UNITED STATES PATENT AND TRADEMARK OFFICE

| APPLICATION NO. | FILING DATE | FIRST NAMED INVENTOR | ATTORNEY DOCKET NO. | CONFIRMATION NO. |
|-----------------|-------------|----------------------|---------------------|------------------|
| 10/632,545 | 08/01/2003 | Michael F. Brletich | 12539 | 2681 |

| Office Action Summary | Application No. 10/632,545 | Applicant(s) BRLETICH ET AL. | |

FIG. 35

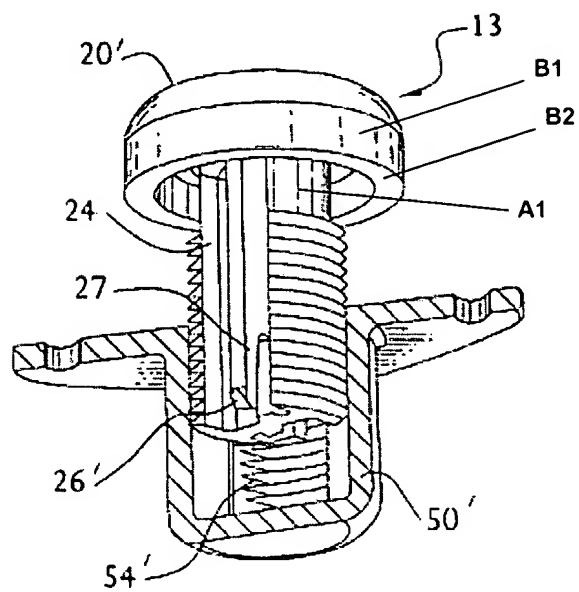
Regarding claim 1, Antonucci et al. disclose, in Fig. 35, a device comprising a fastener plug **13** including a plug portion **20'** and a fastener portion **24**. The plug portion **20'** defines an end cap **20'** and at least one disc **28** spaced apart from the end cap **20'**. The fastener portion **24** defines an extension member **27** extending outwardly from the end cap **20'**. The extension member **27** includes a projecting member **26'**. Applicant is reminded that the disc is sized and shaped to mate with and seal open ends of a bar. Furthermore, the flexible extension member is able to flex as the member is installed in the open ends of the bar and snap back to an original position when the projection member engages an aperture in a sidewall of the bar.

Regarding claims 2-10, the end cap **20'** defines a peripheral edge **B1** and a flat surface edge **B2** along the peripheral edge **B1**. Note, the claims are written with a broad breadth that Antonucci et al. reads on these claims. Applicant should consider rephrasing that the peripheral edge has a truncated edge or truncated surface.

Regarding claims 3 and 11, a rib **A1** connects the disc **28** to the end cap **20'** (see marked-up attachment).

Regarding claims 4 and 12, the disc **28** is a plurality of discs **28** spaced apart from the end cap **20'**.

Regarding claims 5 and 13, the extension member **27** extends upwardly from the end cap **20'**.

Regarding claims 6 and 14, the extension member **27** extends across the discs **28**.

Regarding claim 9, Antonucci et al. disclose, in Fig. 35, a device comprising a fastener plug **13** including an end cap **20'** and at least one disc **28** spaced apart and connected to the end cap **20'**. The fastener plug **13** includes a flexible extension member **27** extending outwardly from the end cap **20'** across the disc **28** and spaced apart from the disc **28**. The extension member **27** has a fixed end **A11** connected to the

end cap 20' and a free end A12 opposite the fixed end A11. The fixed end A11 includes an aperture engaging member 26'.

FIG. 40

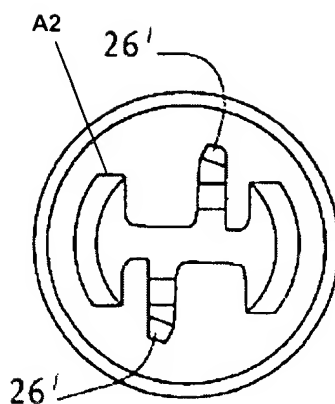
Regarding claim 7, the discs **28** define a flat surface edge **A2** (see marked-up attachment; Figure 40).
